PROJECT: Domain DCP Switchgear Replacement

IFB# CLMC802

SUBJECT: Answers to Bidders Questions as of the date of this letter, per 00100-IFB Article 1.(3)(C).

CENTRAL UTILITY PLANT BUILDING ELEVATIONS

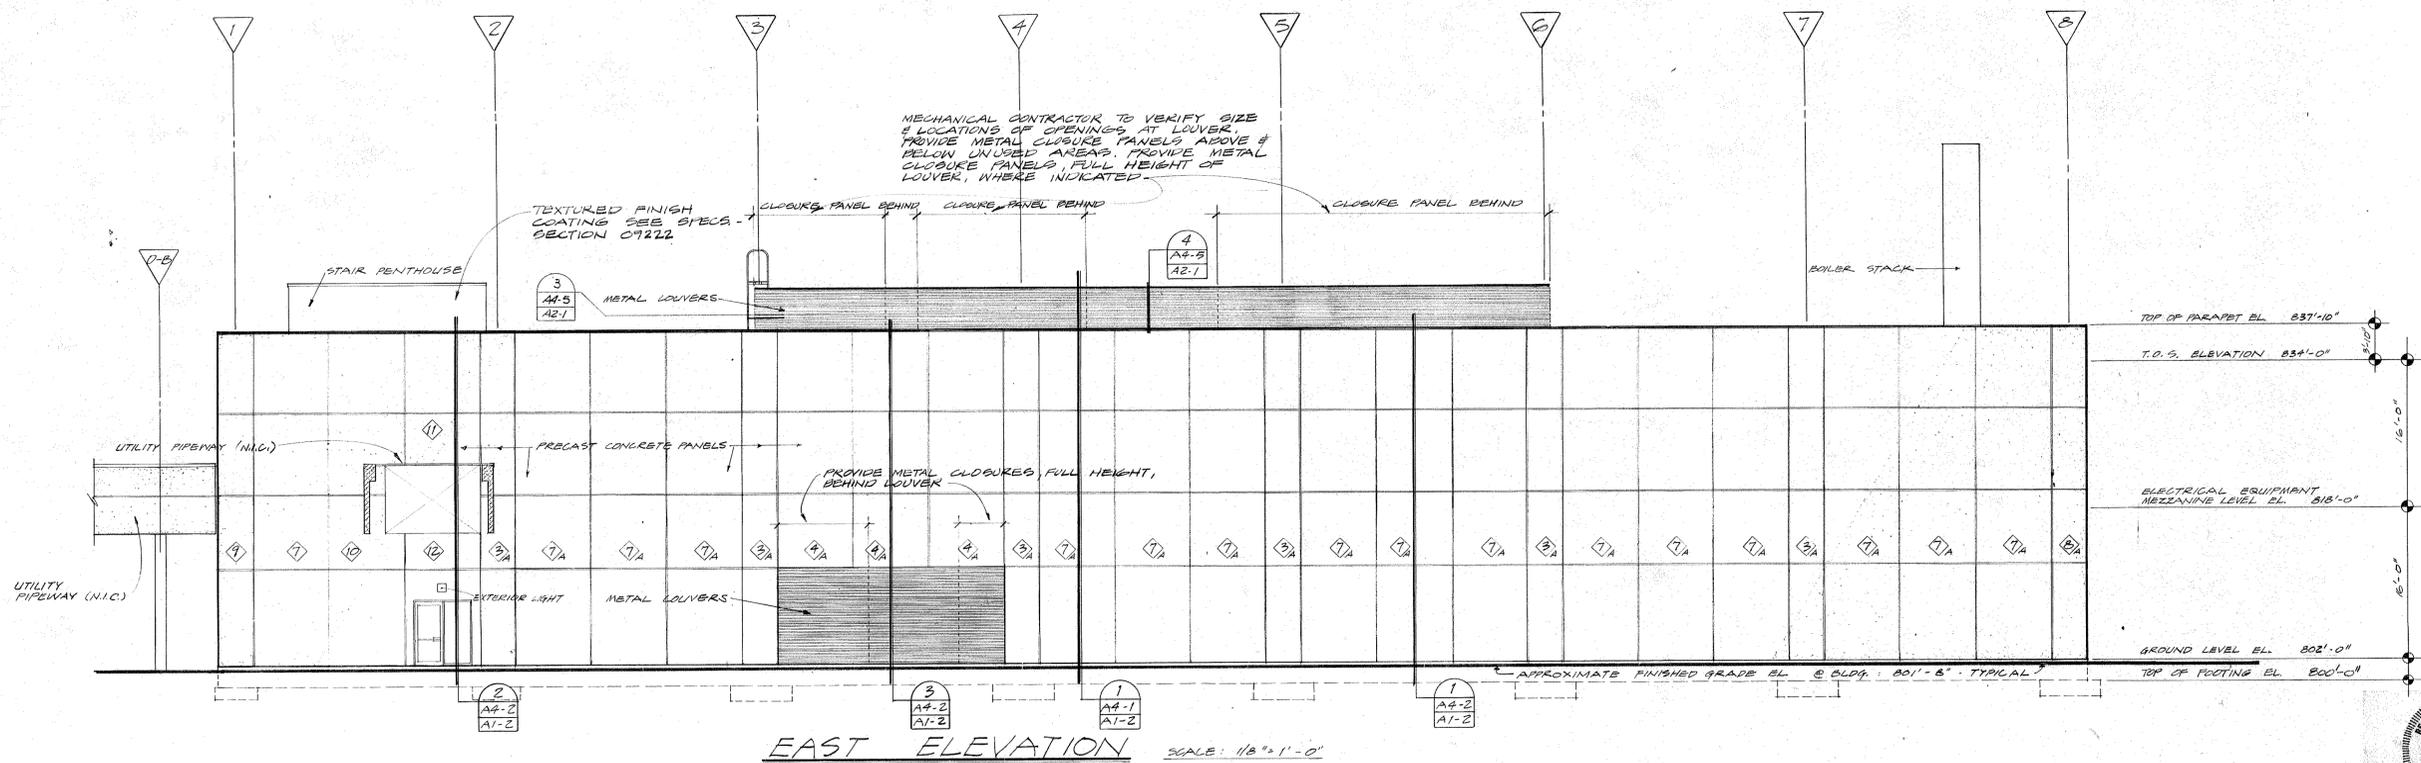
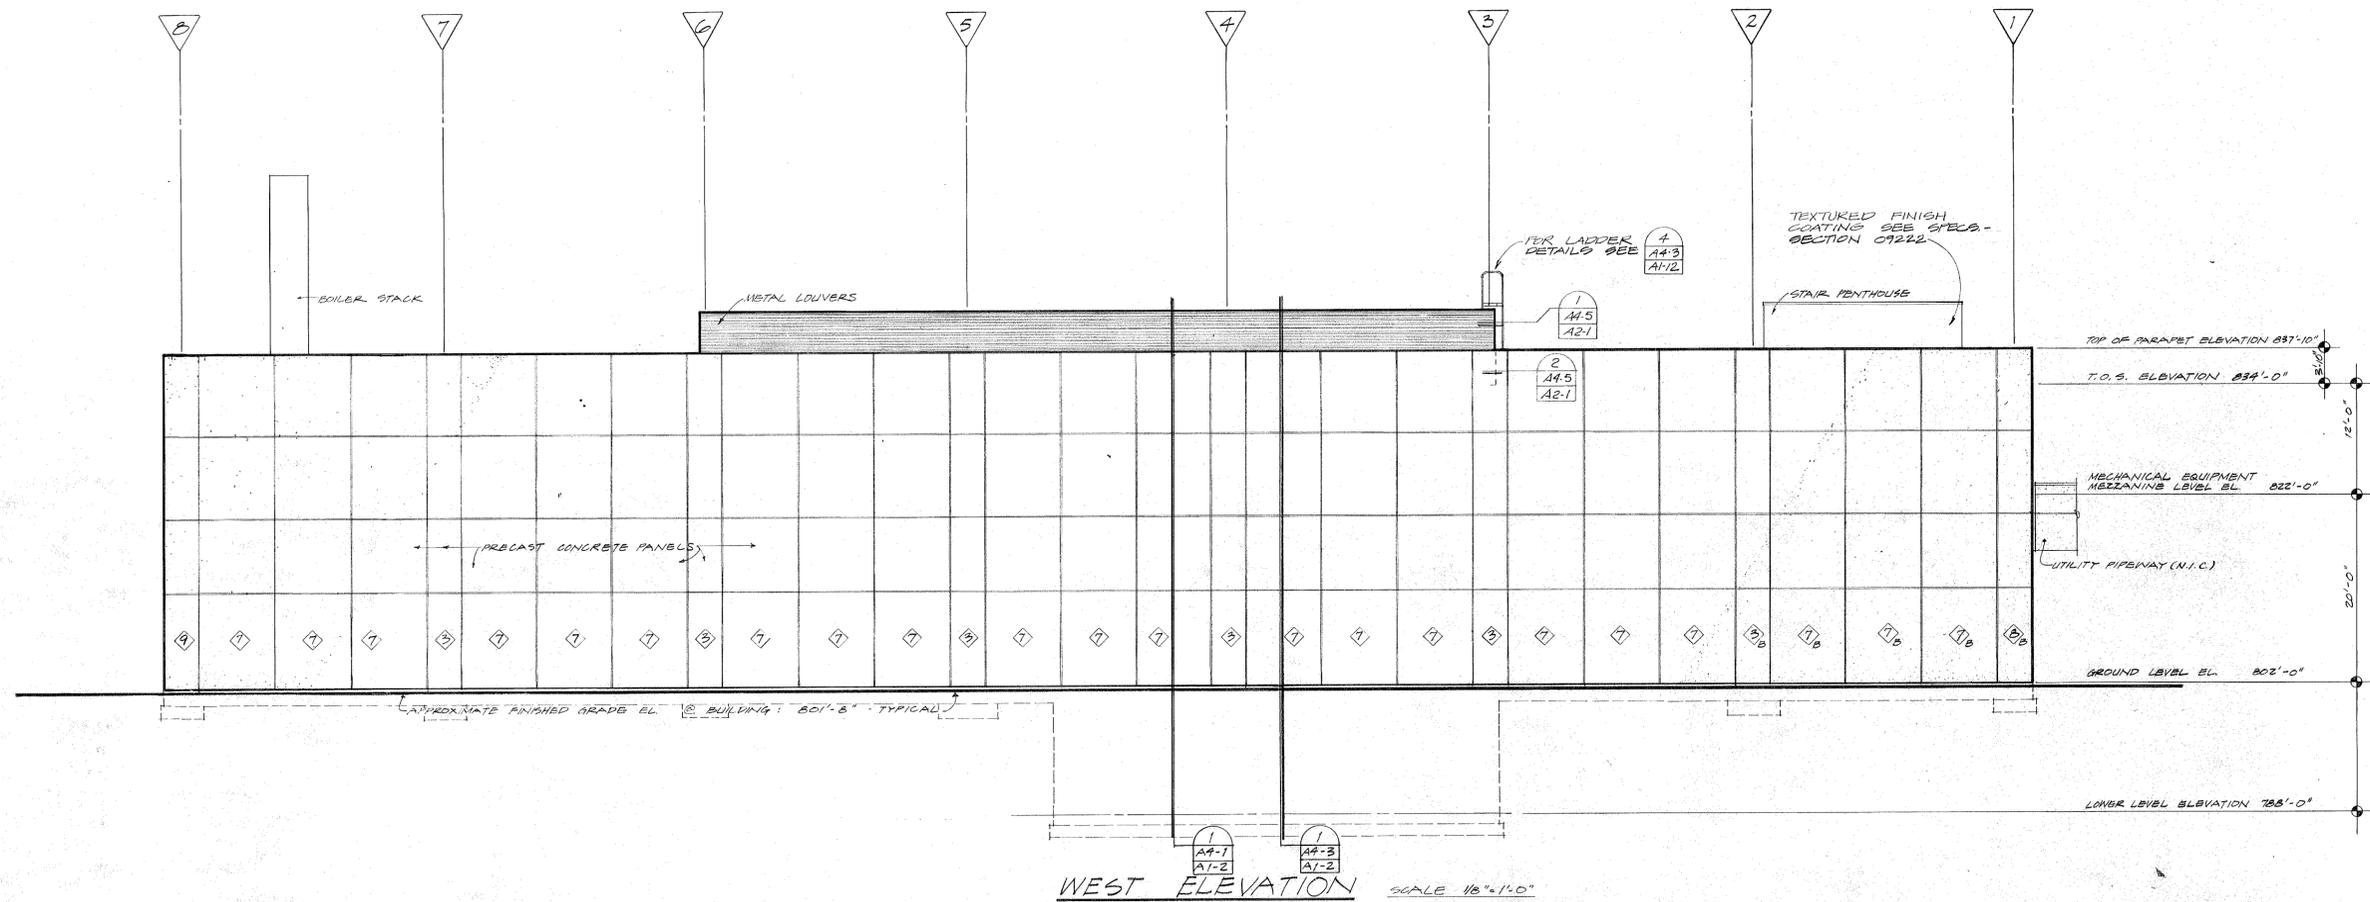
Q-4: The plans do not tell us the vertical spacing between the first floor to the mezzanine under the proposed electrical gear, nor from the floor of the mezzanine to the ceiling above the proposed electrical gear. Please provide these dimensions.

A-4: Architectural drawings/elevations are not included in the scope of this project, therefore, refer to the attached original architectural drawing (A-2) for the Domain chilled water plant dated Dec. 14, 1979.

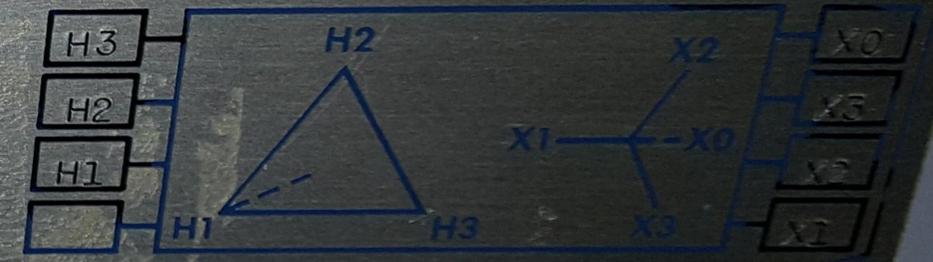
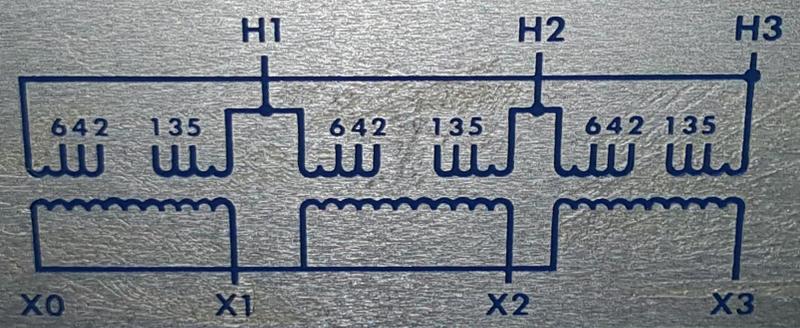
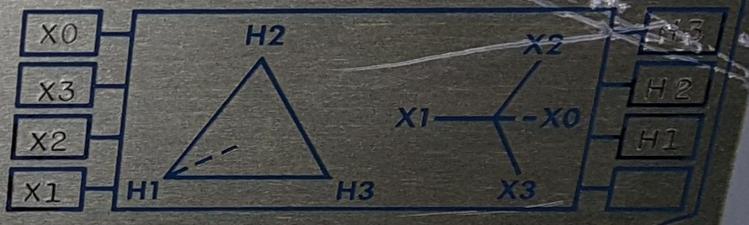
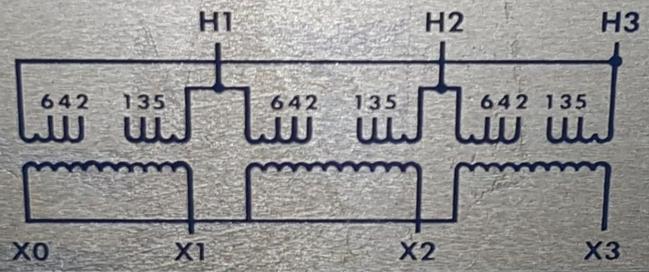
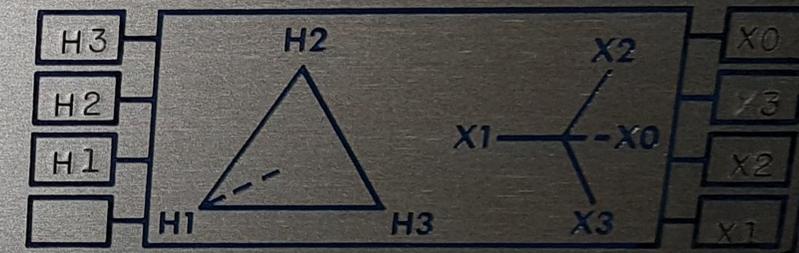
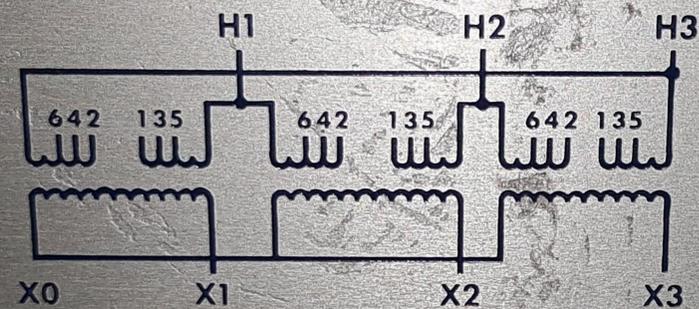
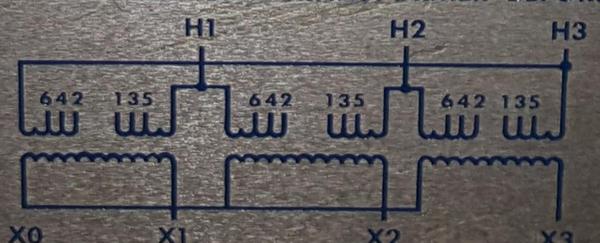
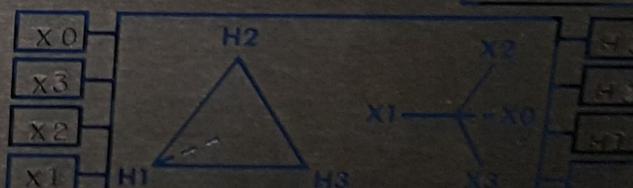
Q-12: I am being asked to quote rigging services for removing the old units and setting in place the new ones. This is very hard to do "sight unseen". Do you have any specs on the old and new equipment? Dimensions and weights specifically but make and model is good enough.

A-12: Refer to drawing E500 for new equipment dimensions and weights. Refer to attached four photographs of existing transformer weights, and attached four photos of as built drawings dated 01/06/1981 showing the weight and dimensions of all three sections of existing unit substations.
